# UNITED STATES PATENT AND TRADEMARK OFFICE

10/708,249

Walter Uebelacker

## DETAILED ACTION

Fig. 3. A schematic drawing of the various shock-wave sources currently in clinical use.

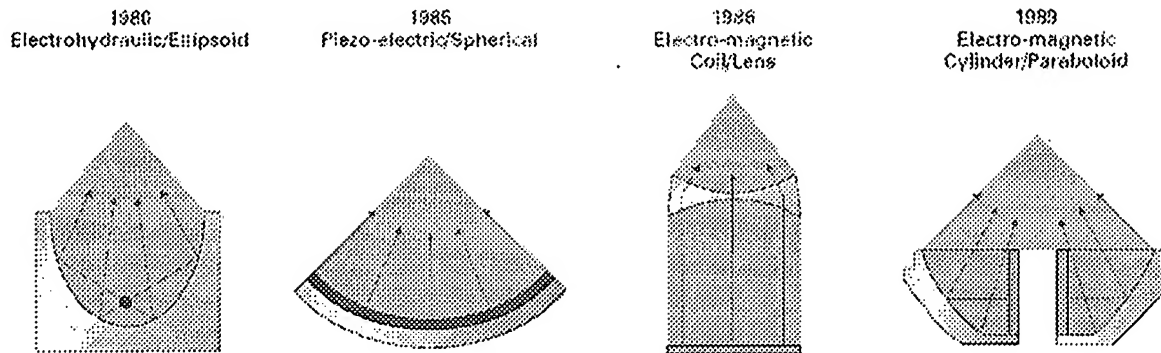
Claim 1-27 are rejected under 35 U.S.C. 101 because the disclosed invention is inoperative and therefore lacks utility. Based on the specification disclosed [0012 and 0013] the task of the present invention is to optimized the interaction of the shock wave with the tissue of a subject being treated so as to achieve the best clinical result. Applicant disclosed that this task is accomplished by using high-energy shock waves are generated by electro hydraulic, electro magnetic or piezoelectric means, but not focused into a focal point. Instead, the shock wave is reflected or refracted in such a way that a plane wave or flat wave is emitted from the source. Furthermore applicant discloses that the structure of the present apparatus comprises of a reflector housing, a parabolic reflector disposed in the hosing and energy source [0015, line 1-4]. And, in an embodiment, the energy source may have a propagation point centered approximately at the focal point of the parabolic reflector [0016]. In view of one ordinary skill in the art at time of this invention was made studies show that reflection of the waves emitted from the energy source based on the location disclosed by the applicant will not result in a plane wave or flat wave format. Please see the following reference.

Re Claim 1, 4, 17, 18: Wilbert discloses a therapeutic shock wave device and method comprising a reflector housing, a parabolic reflector and an energy source and coupling member (See Paragraph 1, 3 and Fig. 3).

Re Claim 6 and 7: Wilbert disclose that the energy source is an electro-hydraulic source, (See paragraph 13, "titled principle of shock wave generation" and Fig.3a).

Walbert teaches method of using electro-hydraulic, electromagnetic or piezoelectric and reflecting the shockwave from a parabolic reflector, (See Fig. 3).
